From:	Marnie Collier
То:	Nai Saephan
Subject:	CDTP24-00064 19 Jay Court - Summary of All Data: Plans, County Approvals and Conditions -CIMS RESPONSE 03/17/25
Date:	Monday, March 17, 2025 9:58:07 AM
Attachments:	P 39-23_19_Jay Ct conditional approval notice follow-up.pdf P 39-23_19_Jay Ct plant listing.pdf P 39-23_19_Jay Ct conditional approval notice after appeal.pdf P 39-23_19_Jay Ct approval notice.pdf

Subject: CDTP24-00064 Urgent Community Opposition to Tree Removal and Ground-Mounted Solar Permits at 19 Jay Ct, Alamo

CDTP24-00064

ENGINEER'S OPINION LETTER

19 Jay Ct Alamo, CA Fault Map

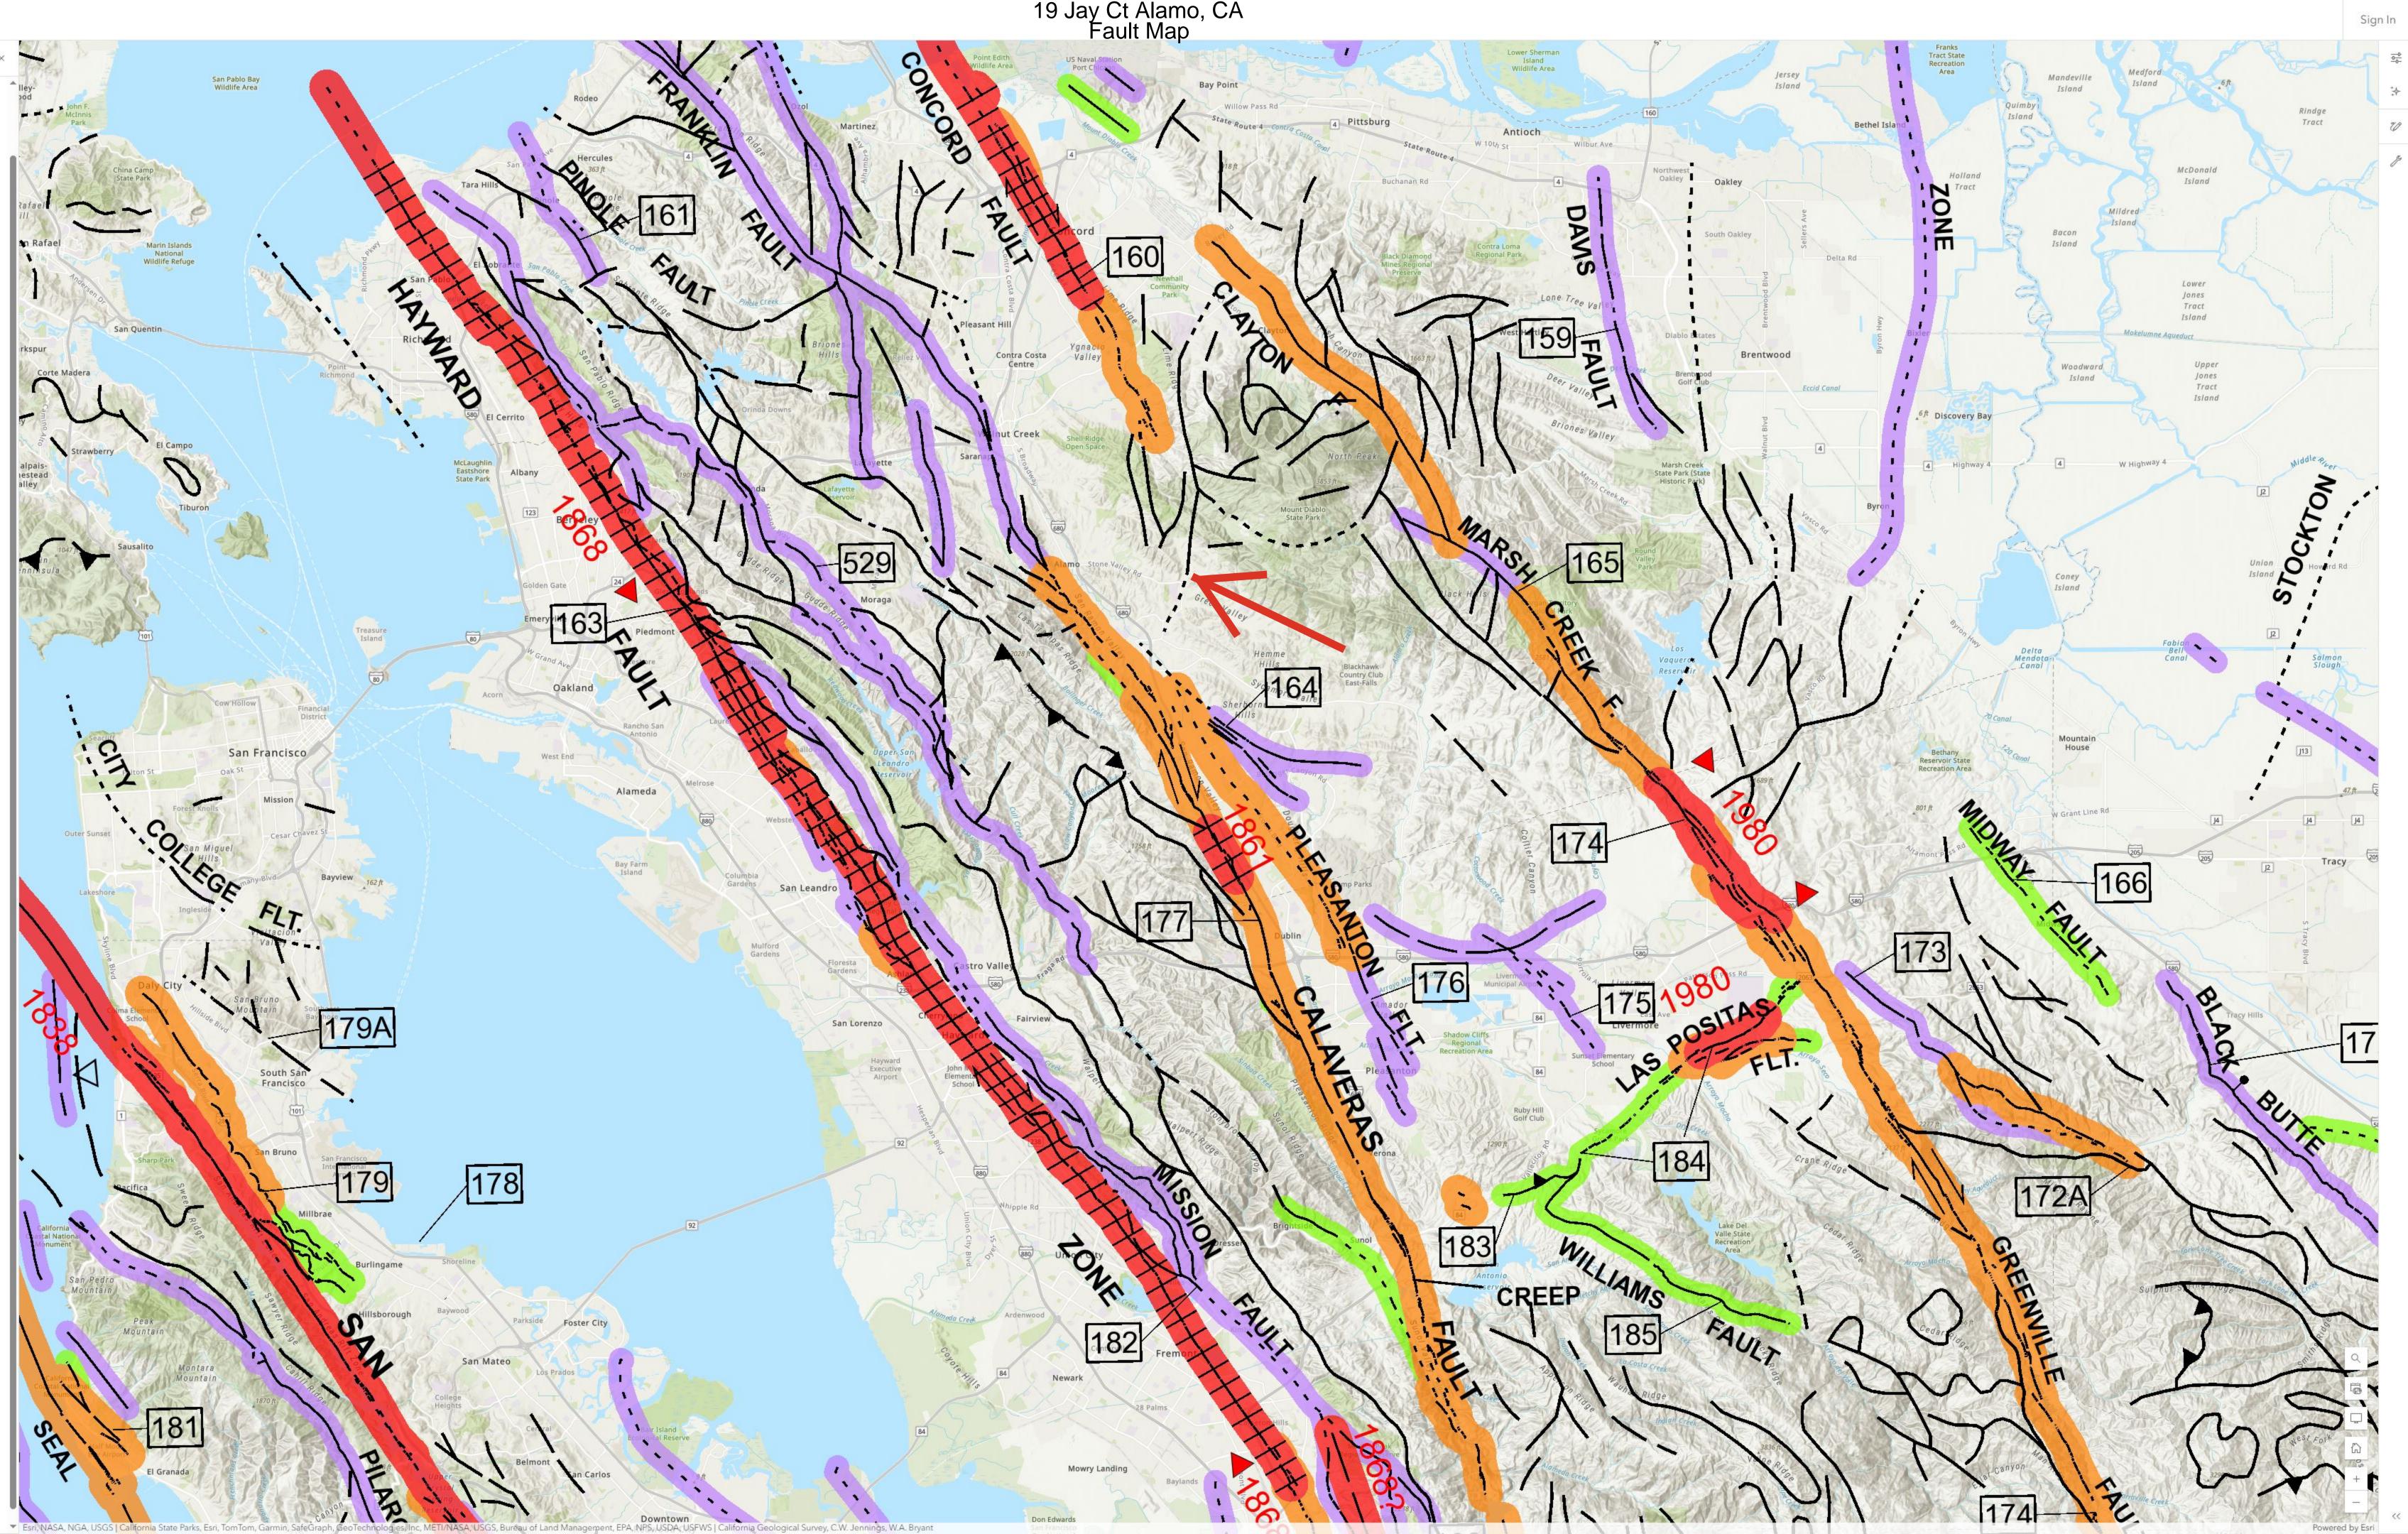
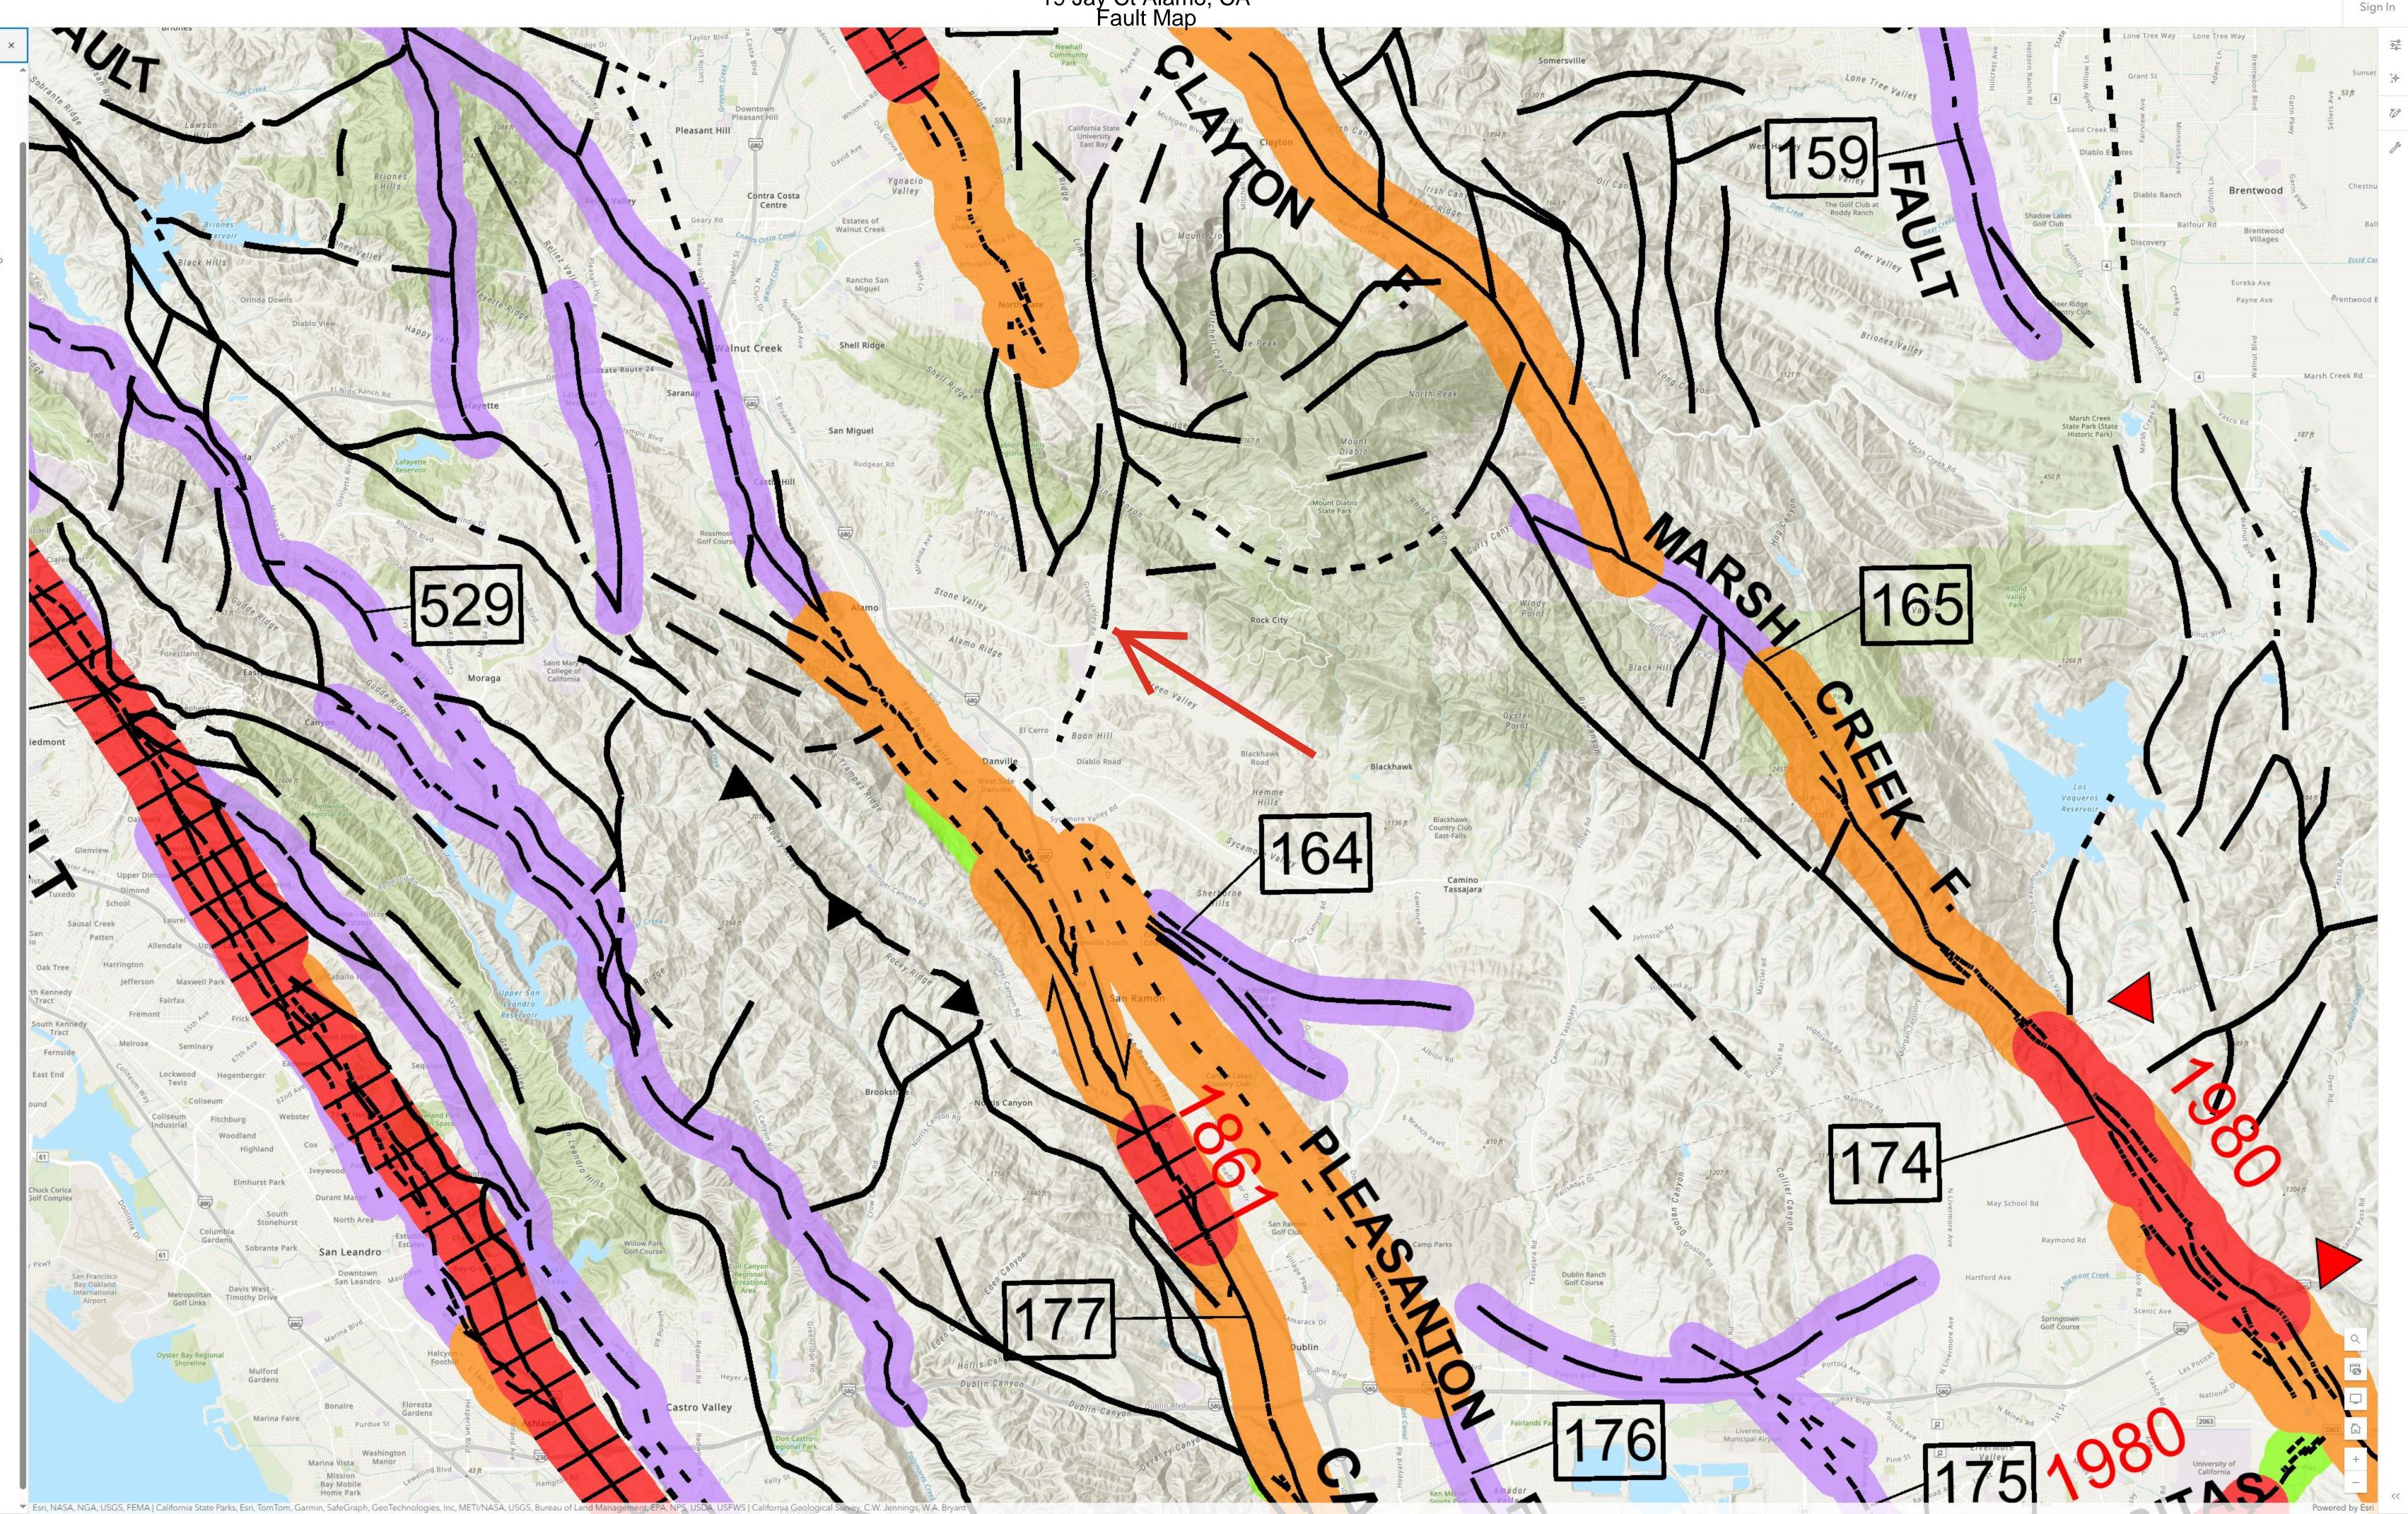
EARTHQUAKE FAULT

The proposed location is very close to an earthquake fault. [Ref: Zoom Map to see Green Valley fault near Stone Valley Road, attached.]

During construction, excavations in this area are subject to earthquake loading.

Following construction, the proposed ground mounted solar panel system is subject to earthquake loading. This seismic loading must be considered by the civil/structural engineer.

Prior to any excavations on this embankment, Geissler Engineering recommends requiring a soil report to better evaluate the potential for seismic loading.
